Report date range from: 2/18/2026 12:00:01 PM to: 2/19/2026 4:45:00 PM

CD-1 Rezoning: 2028-2038 Barclay Street - Oppose

Figure 4 Hotel Proposal and Allowable Building Envelopes for RM-5B

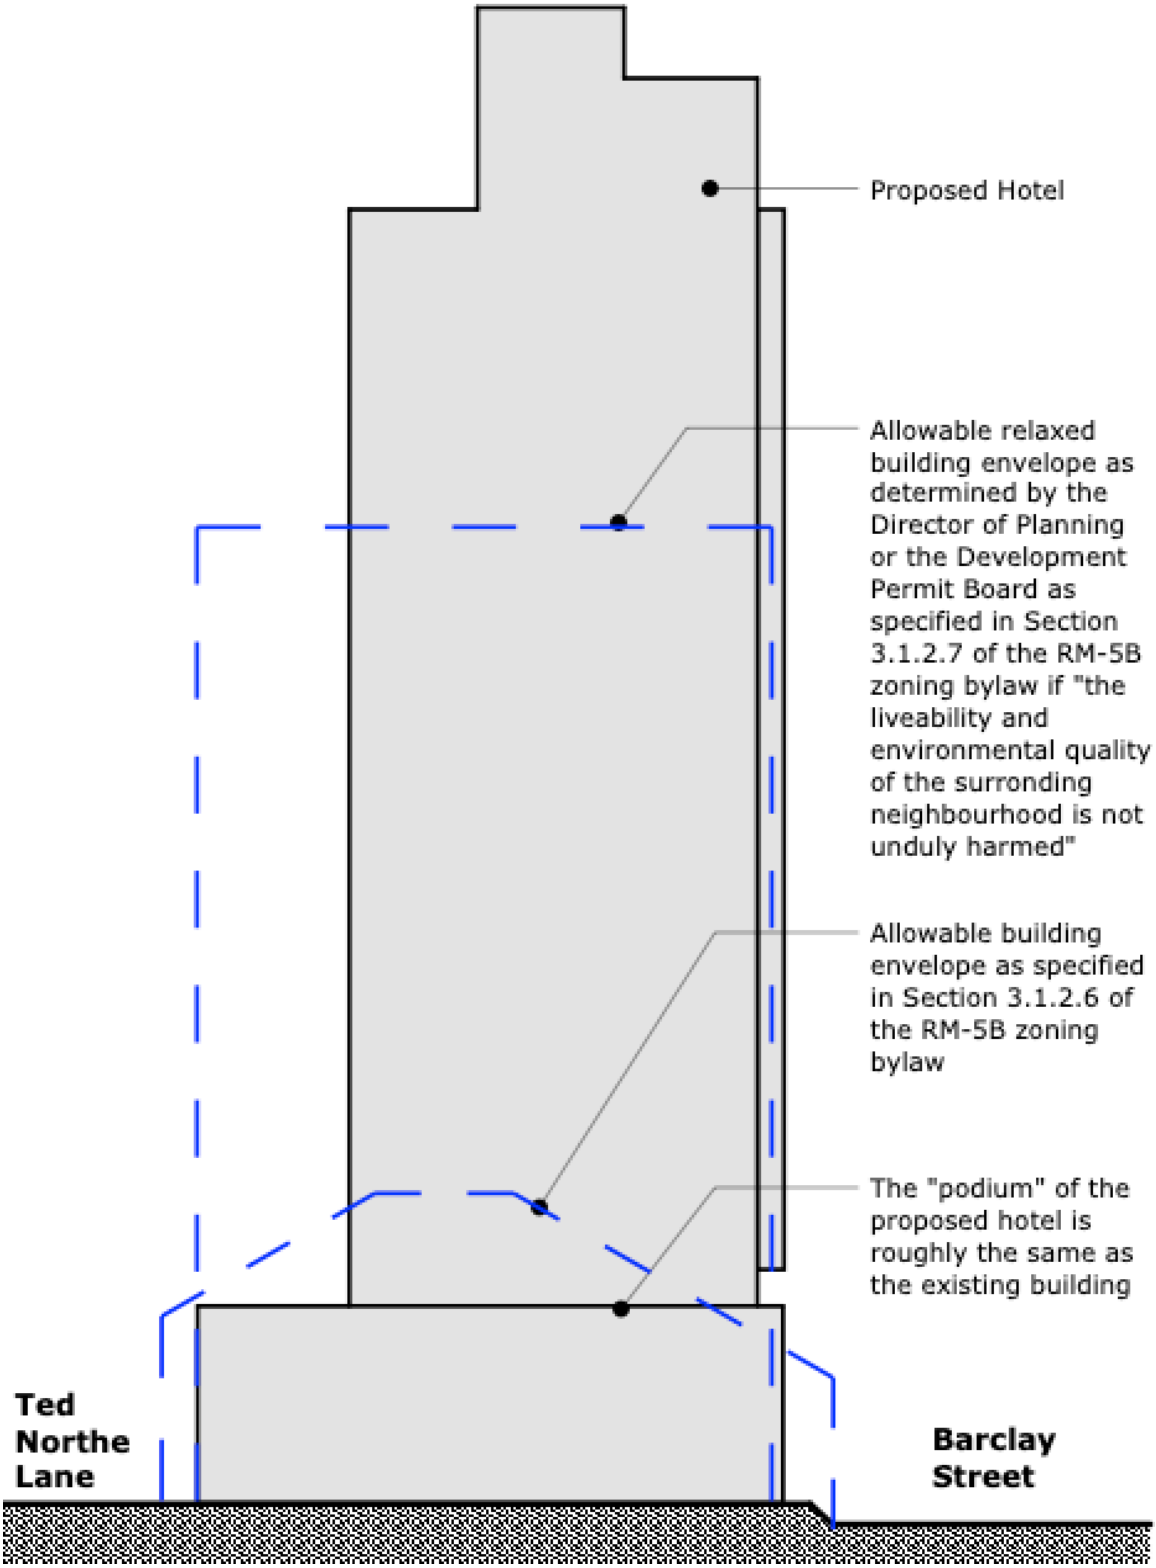
The proponents ignore the reality that 2030 Barclay is not at the edge but rather mid block. More seriously, while the proposal is the tallest in the neighbourhood by 1 floor, it has by far the highest FSR at 12.75 west of Denman and most likely anywhere in the RM-5B zone. This outrageous density which is more than 4 times the allowable and doesn't even include the "back of house" floor area, is more in line with densities being given to properties along the Georgia/Alberni and Burrard/Thurlow corridors, but completely at odds with the goals of the WECP, which were to preserve the diverse building types in the body of the West End.

Figure 4 shows the proposal within the context of the building envelope prescribed by the RM-5B zoning district. The taller relaxed height is achievable if the Director of Planning or the Development Permit Board considers: "(a) the intent of this schedule and all applicable Council policies and guidelines; (b) the submission of any advisory group, property owner or tenant; and (c) the impact on public and private views, sunshine, privacy and open spaces." There is no provision within the RM-5B zoning district for a building of the scale being proposed.
